Access Compliance Report Public Rights-of-Way (Curb Ramps)

Main Street: HARRISBURG_RD Cross Street: PEMBERTON_RD Location: NW

ADA ID: RPRK211215120718 Ramp Type: Type 1 - Perpendicular Diagonal Initial Pass/Fail: Fail Overall Compliance: No Severity Score: 15

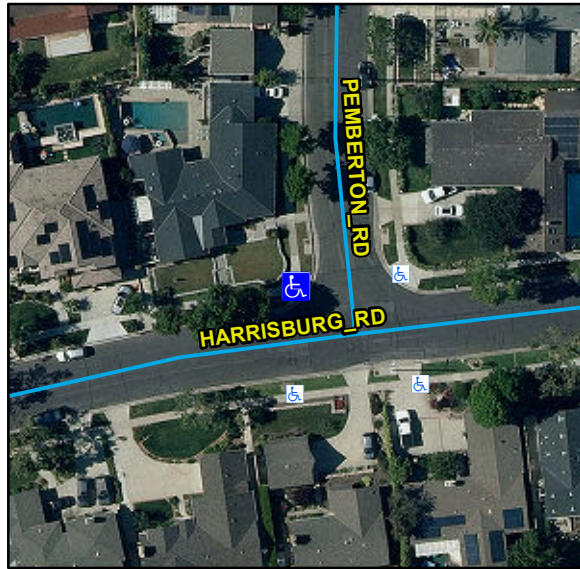
Compliance	Description	Data	Compliance	Description	Data
N/A	Ramp Length (in)	86	N/A	Flare Type LT	
Yes	Ramp Width (in)	48			N/A
No	Ramp Run Slope (%)	8.4	N/A	Flare Slope LT (%)	N/A
Yes	Ramp Cross Slope (%)	0.3	N/A	Flare Traversable LT	N/A
N/A	Landing Present	N/A	N/A	Flare Type RT	
N/A	Landing Length (in)	N/A			N/A
N/A	Landing Width (in)	N/A	N/A	Flare Slope RT (%)	N/A
N/A	Landing Run Slope (%)	N/A	N/A	Flare Traversable RT	N/A
N/A	Landing Cross Slope (%)	N/A	N/A	DWS Provided	N/A
N/A	Landing Movement Obstructed?	N/A	N/A	DWS Contrast	N/A
	Landing Movement Type	N/A	N/A	DWS Length (in)	N/A
N/A	Landing Shared	N/A	N/A	DWS Full Width	N/A
N/A	Clear Space	Yes	N/A	DWS Offset Left (in)	N/A
N/A	Clear Space To Crosswalk (in)	N/A	N/A	DWS Offset Right (in)	N/A
N/A	Marked Crosswalk 1	No	N/A	Marked Crosswalk 2	No
	Crossing 1 Direction	S		Crossing 2 Direction	E
	Marked Crosswalk 1 Width (in)	N/A		Marked Crosswalk 2 Width (in)	N/A

Remove & Replace Curb Ramp With Two New Directional Ramps or Equivalent.
